Technical Information Bulletin

Subject: **Door Solenoid**
Machine: **Shopper 2 (432)**
Issue No: **TI0023**
Date: **28/11/06**

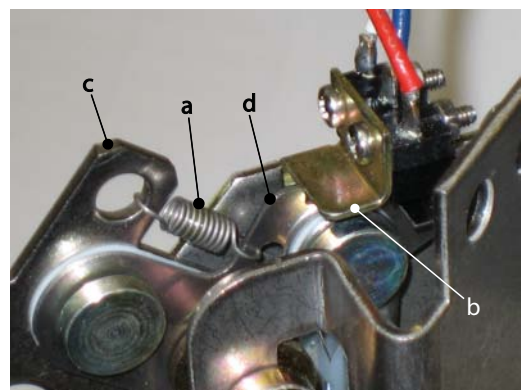
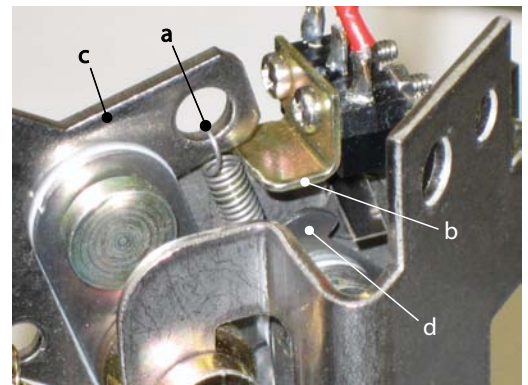
Following customer feedback, Crane Merchandising Systems (CMS) has been made aware that on occasion the vend doors can stick and fail to open.

On investigation it has been found that the small spring (a) towards the top of the solenoid assembly is intermittently catching on the micro switch mounting/cam stop bracket (b). This is stopping the stop bracket (c) from moving and therefore not allowing the door to be opened.

If this is happening the solution is to very slightly bend up the bracket (b) to clear the spring (a), but not enough to clear the cam stop (d).

Remove the solenoid assembly from the machine door. Using a pair of long nose pliers slightly bend up the bracket (b).

Check to ensure that the cam stop (d) engages on the bracket (b).
